# **Lindsey Street Improvement Project**

**City of Norman 2012 Bond Project**

## **City Council Conference**

**August 27, 2013**

## Typical Roadway Design

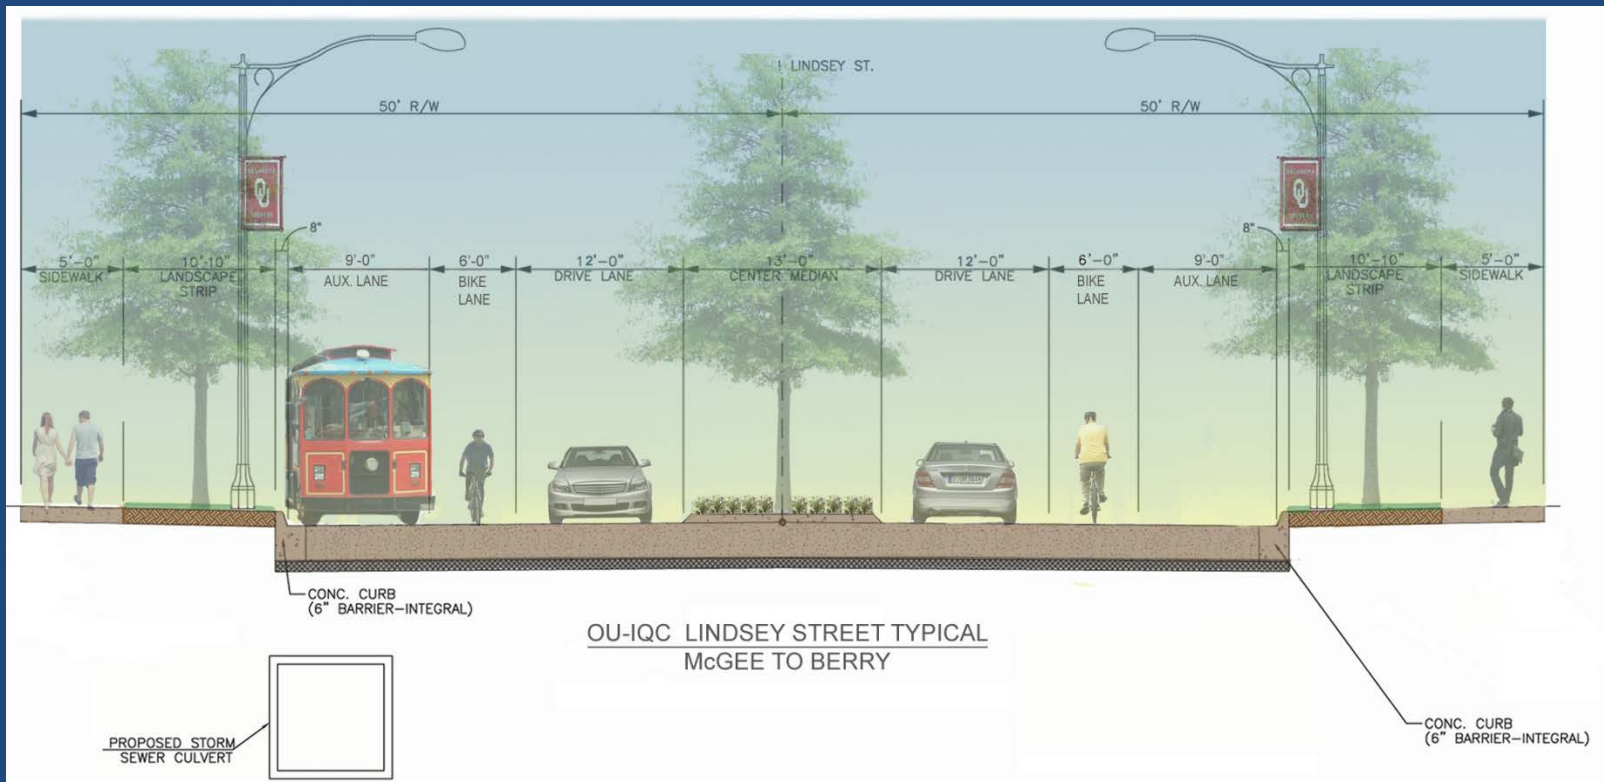
- 2 vehicular travel lanes with 12 foot lanes and auxiliary lanes
- 6-foot bike lanes
- 9-foot Auxiliary lanes (could be used for bus pull outs or egress/ingress)
- Total distance curb to curb - 67 feet (same paving as current cross section)
- Road fits within the 100 foot ROW (roundabouts may require additional ROW)
